Tokio mode Limited (10350)

98/173 Choydana, National University, Gazipur, Bangladesh

20.May.2014

Identified Priority 2 Concerns

Escape Staircase construction isn't strong

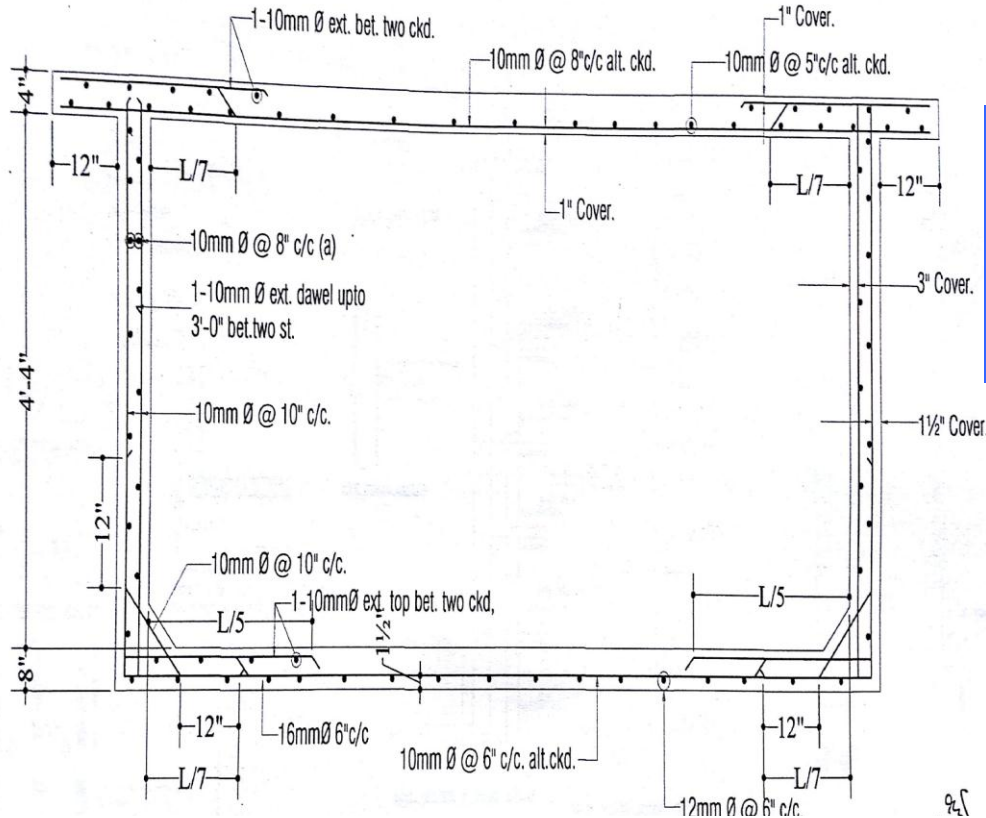
The staircase at the side of Building is meant to be a fire escape. This means that there is a potential for crowds of people to use this stair in the event of emergency. However, the stair was built from very small steel members. The structural stability of this staircase is questionable, and it appears not to comply to BNBC load requirements for exits. Furthermore the staircase wasn't shown on any of the structural drawings.

Lack some information about foundations

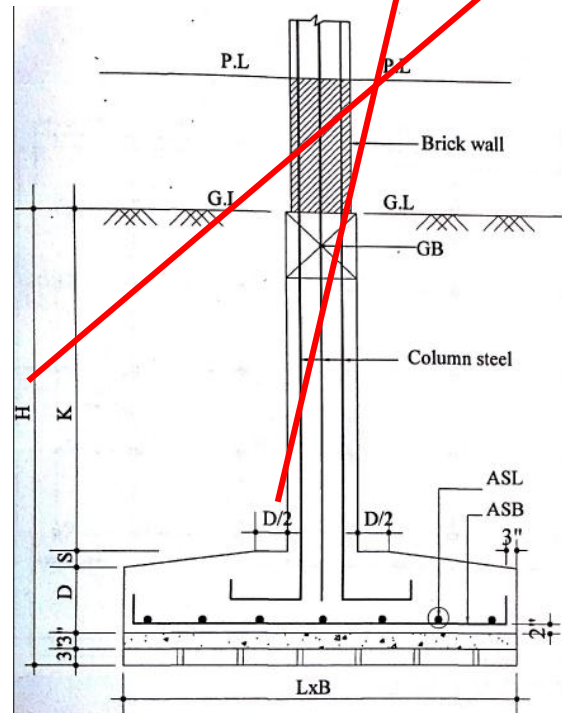
Not enough information in table on foundation detail:

- H
- D2
